PLANNING COMMISSION AGENDA CITY OF PRAIRIE VILLAGE MUNICIPAL BUILDING - 7700 MISSION ROAD TUESDAY, FEBRUARY 7, 2012 COUNCIL CHAMBERS 7:00 P. M.

PLANNING COMMISSION MINUTES January 10, 2012

SUBJECT: PC 2012-02 Proposed Amendments to the Park and Recreation Master

PC 2012-01 Amendments to Zoning Ordinance to Incorporate Alternative

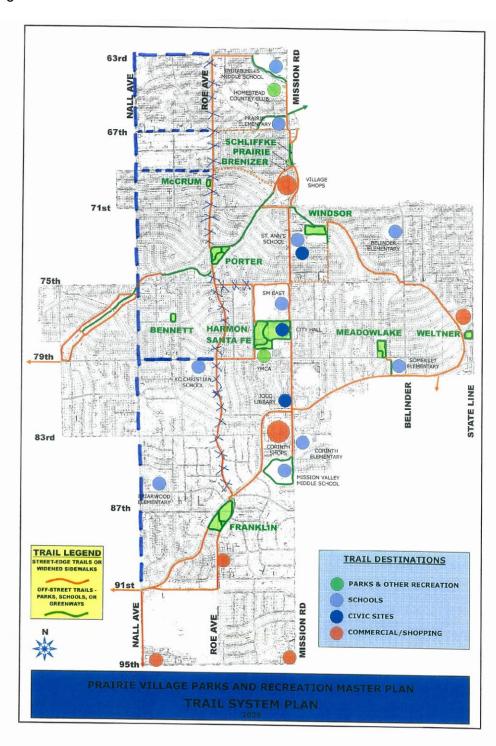
The City has been implementing the Bike/Trial Plan as part of the Park Master Plan and has determined Nall Avenue will be the trail route rather than Roe Avenue as shown in the Park Master Plan. The Park Master Plan needs to be amended to effect this change.

The attached Trail System Plan shows the proposed changes and the other two maps will need to be changed accordingly if the amendment is approved. The Roe Avenue Trail is marked with an "X" and the proposed Nall Avenue Trail is shown as a dashed line along the trail. Also the extensions of 63rd Street, 67th Street, 69th Street and 79th Street from Roe Avenue to Nall Avenue are shown in a dashed line. Staff is recommending the trail on 75th Street west of Shawnee Mission East be deleted because of significant right-of-way constraints.

It is the recommendation of Staff that the Planning Commission adopt the Resolution amending the Park and Recreation Master Plan or Village Vision by changing the Bike/Trail from Roe
